MIL-PRF-22885/111A
 AMENDMENT 1
 6 June 2003

PERFORMANCE SPECIFICATION SHEET

SWITCHES, PUSHBUTTON, LIGHT EMITTING DIODE (LED) ILLUMINATED,
 STANDARD, NIGHT VISION IMAGING SYSTEM (NVIS) AND SUNLIGHT READABLE DISPLAYS,
 SPDT AND DPDT, LOW LEVEL TO 7 AMPERES, SEALED AND UNSEALED,
 SOLDER AND COMMON TERMINATION SYSTEM (CTS) TERMINATIONS

This amendment forms a part of MIL-PRF-22885/111A, dated 5 September 2000, and is approved for use by all Departments and Agencies of the Department of Defense.

Figure 3, Delete and substitute with

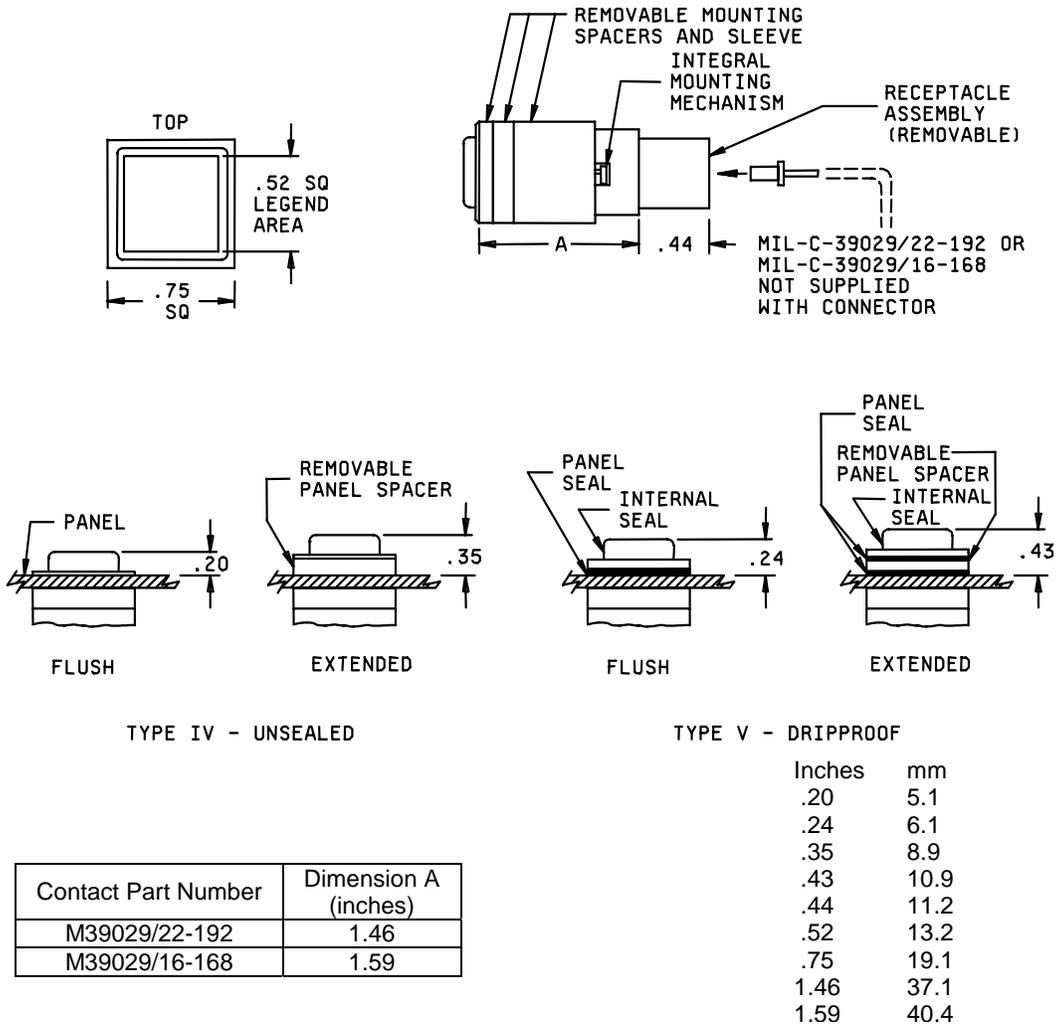
Note 7, delete and substitute:

"7. The CTS pins shall be M39029/22-192 or M39029/16-168 and shall be removable from the CTS module assembly. The CTS pins accept 20, 22, or 24 gauge wire."

Figure 4, Delete and substitute with

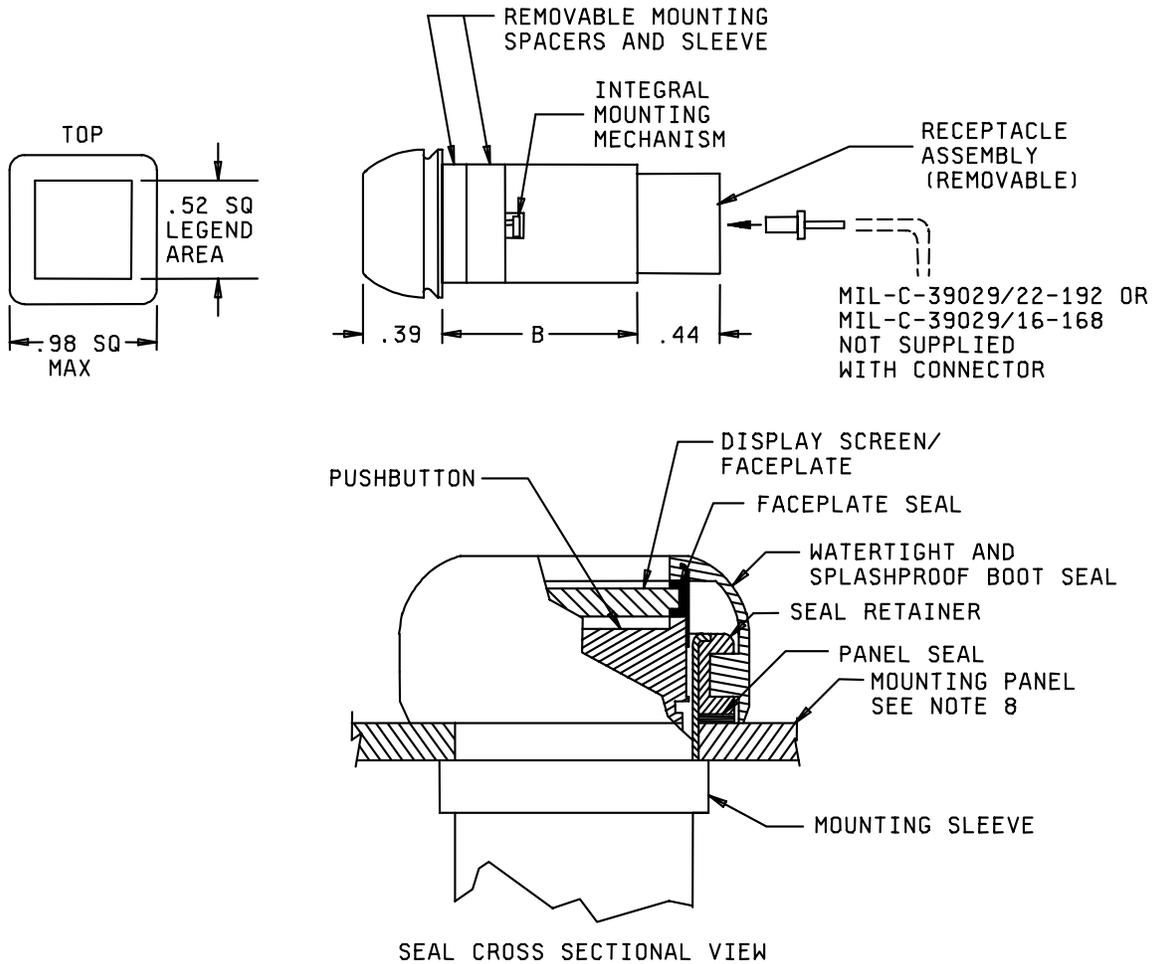
Note 7, delete and substitute:

Contact Part Number	Dimension B (inches)
M39029/22-192	1.30
M39029/16-168	1.43

"7. The CTS pins shall be M39029/22-192 or M39029/16-168 and shall be removable from the CTS module assembly. The CTS pins accept 20, 22, or 24 gauge wire."
